# Access Compliance Report

## Public Rights-of-Way

### (Curb Ramps)

Intersection ID: 10396	Main Street: DADE_ST	Cross Street: THE_PLAZA	Location: E
ADA ID: 7EFD7F10D088	Ramp Type: Perp	Initial Pass/Fail: Fail	Overall Compliance: No
			Severity Score: 21.25

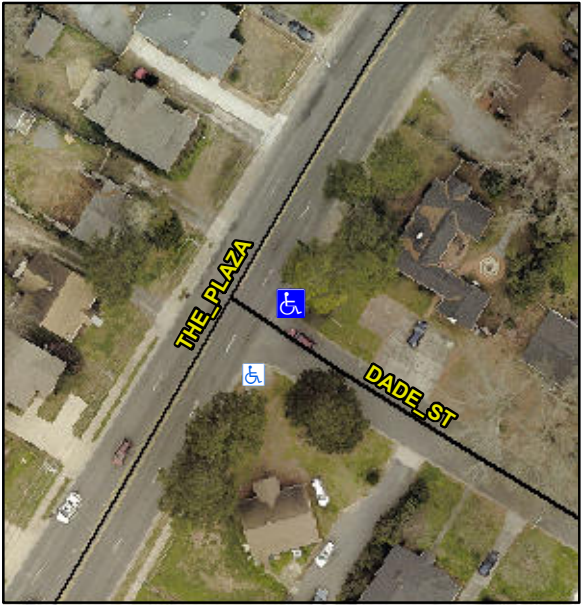
Codes/Mitigation Info/Possible Solution			Field Measurements/Component Compliance		
	Possible Solutions:		<b>Compliance</b>	<b>Description</b>	<b>Data</b>
	<b>Remove &amp; Replace Entire Ramp.</b>		<b>Yes</b>	Ramp Slope (%)	7.9
			<b>No</b>	Ramp XSlope (%)	6.7
			<b>N/A</b>	Flare Type LT	N/A
			<b>N/A</b>	Flare Slope LT (%)	N/A
			<b>N/A</b>	Flare Traversable LT?	N/A
			<b>N/A</b>	Landing Length (in)	N/A
			<b>N/A</b>	Landing Width (in)	N/A
			<b>N/A</b>	Landing Slope (%)	N/A
			<b>N/A</b>	Landing X Slope (%)	N/A
<p>Surveyor Notes:</p> <p><b>N/A</b></p>			<b>N/A</b>	Landing Curb? (Y/N)	N/A
			<b>N/A</b>	Shared Landing?	N/A
			<b>N/A</b>	Gutter Ponding?	N/A
			<b>N/A</b>	Gutter Lip Ht (in)	0.5
			<b>N/A</b>	Painted X Walk1?	No
				X Walk 1 Direction	To SW
			<b>N/A</b>	X Walk 1 Width (in)	N/A
				X Walk 1 Slope (%)	0.2
				X Walk 1 X Slope (%)	5.5
			<b>N/A</b>	Ramp inside XWalk1?	N/A
<p>PROW/ADA:</p> <p><b>R304.5.1, R304.5.3</b></p>			<b>N/A</b>	Road Slope (%)	N/A

<b>N/A</b>	Road X Slope (%)	N/A
			<b>N/A</b>	Any Obstructions?	N/A
				Obstruction Type	
			<b>N/A</b>		
			<b>N/A</b>		
			<b>N/A</b>		
			<b>N/A</b>		
			<b>N/A</b>		
			<b>N/A</b>		
<p>Total Cost:</p> <p><b>\$ 1850.00</b></p>			<b>N/A</b>	Clear Space?	N/A
			<b>N/A</b>	Clear Space to XWalk (in)	N/A
			<b>N/A</b>	Storm Grate/Utility Hazard?	N/A
				Storm Grate/Utility Type	
			<b>N/A</b>		
			<b>N/A</b>		
			<b>N/A</b>		
			<b>N/A</b>		
			<b>N/A</b>		
			<b>N/A</b>		
<p>Street 1 Name</p> <p><b>DADE ST</b></p> <p>Stop Condition-Street 2</p> <p><b>StopSign</b></p> <p>Street 2 Name</p> <p><b>N/A</b></p> <p>Stop Condition-Street 1</p> <p><b>N/A</b></p>			<b>Yes</b>	Surface Condition? (G/P)	Good
